RE: Nuestros Valores Charter High School

Grading Plan Stamp Date: 4/28/17 Hydrology File: L10D007

Based upon the information provided in your submittal received 5/9/2017, the Grading Plan **is not** approved for Building and Grading Permit. The following comments need to be addressed for approval of the above referenced project:

C101 Rio Rancho, N.M. 87124

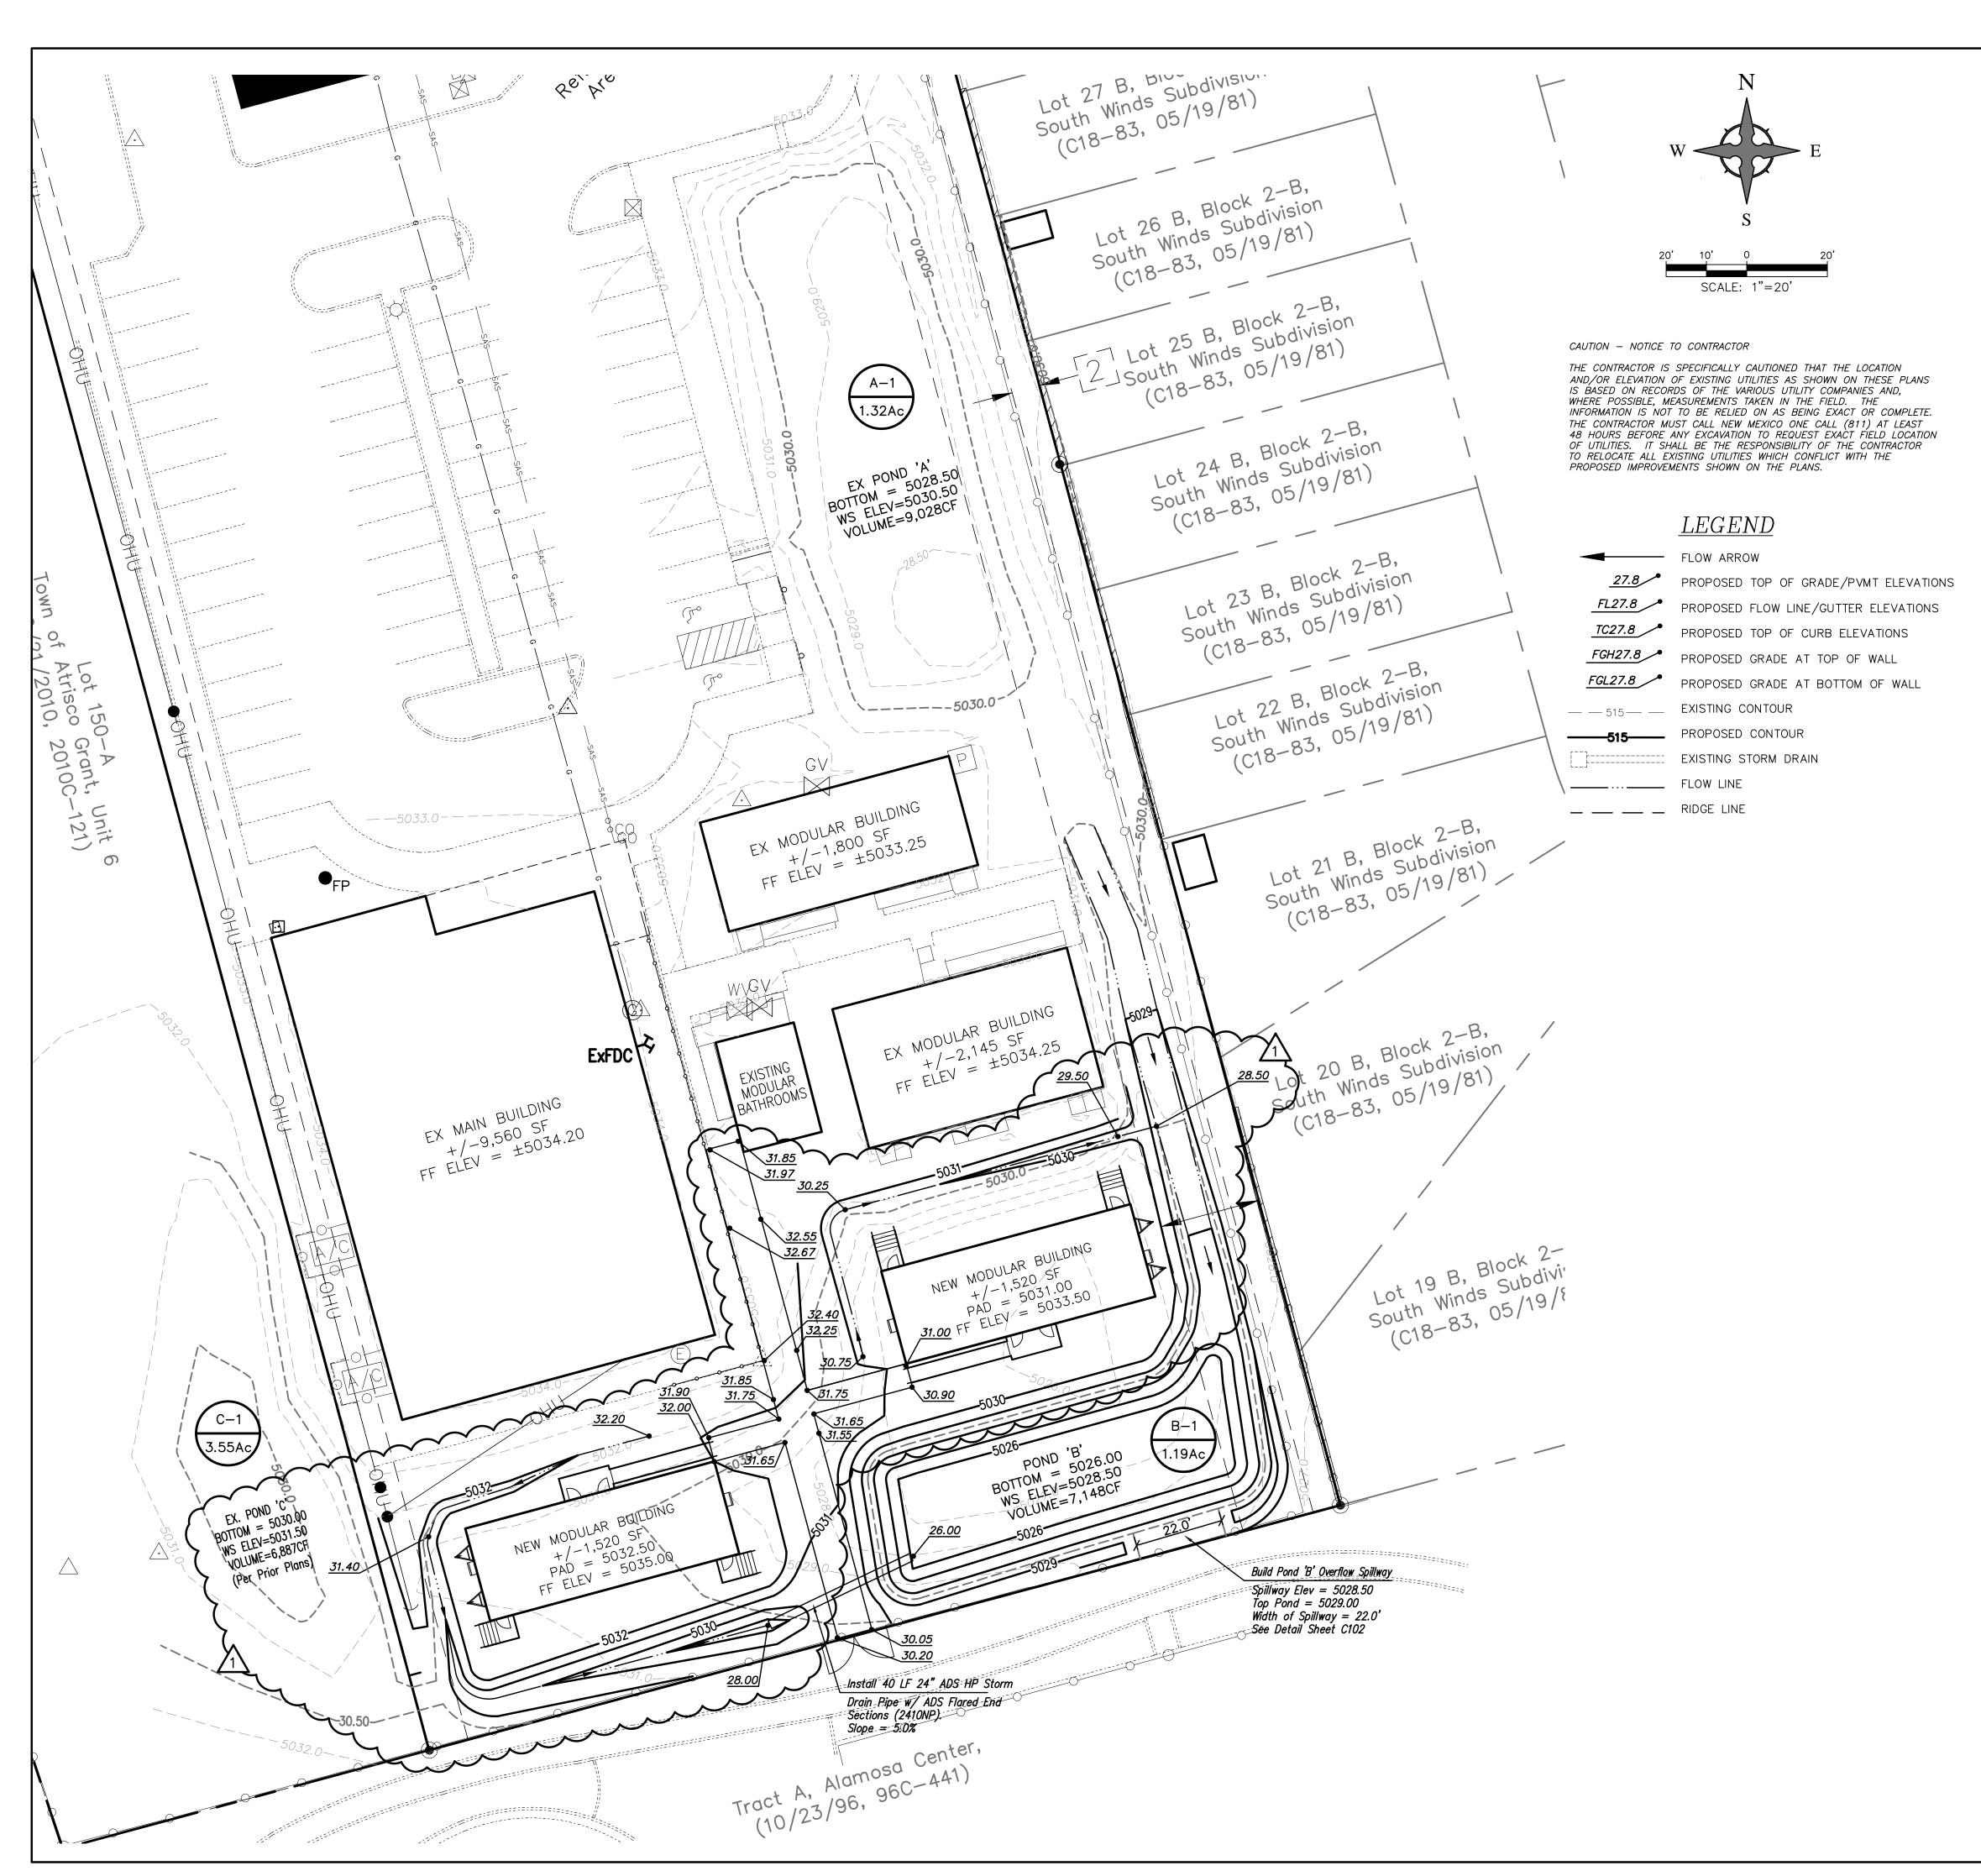
1. On C101, please provide benchmark information.

- 4. On C102, according to the drainage calculations provided, the required 100-yr, 10 day storm volume for Pond A is 10,802 CF and not 6,810 CF. Pond B required volume is 9,832 CF and not 6,382. Please correct the required 100-yr, 10 day storm volume for Ponds A & B.
- 5. On C101 & C102, based on the above comment, Pond A & B are currently sized too small to handle the 100-yr, 10 day storm. Please resize both ponds to meet the required volume.
- 6. On C102, Please proved an overall drainage basin map for the three basins along with the ponds and the drainage flow arrows.

C102

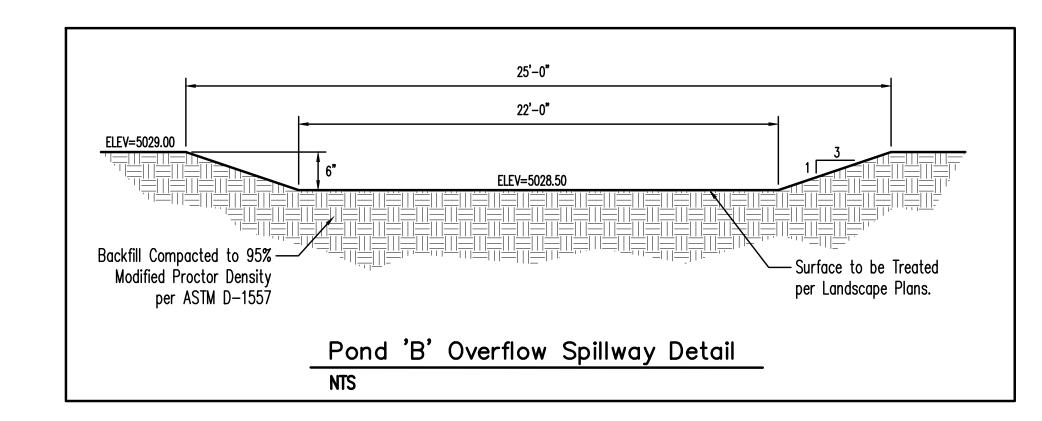
- 2. On C102, under the Proposed Hydrologic Conditions the ponds are stated to be designed for the 100-yr, 6 hr storm. Per the CoA DPM, the retention ponds are to be sized for the 100-yr, 10 day storm. Please revise.
- 3. Please provide the AHYMO routing output for the retention pond system.
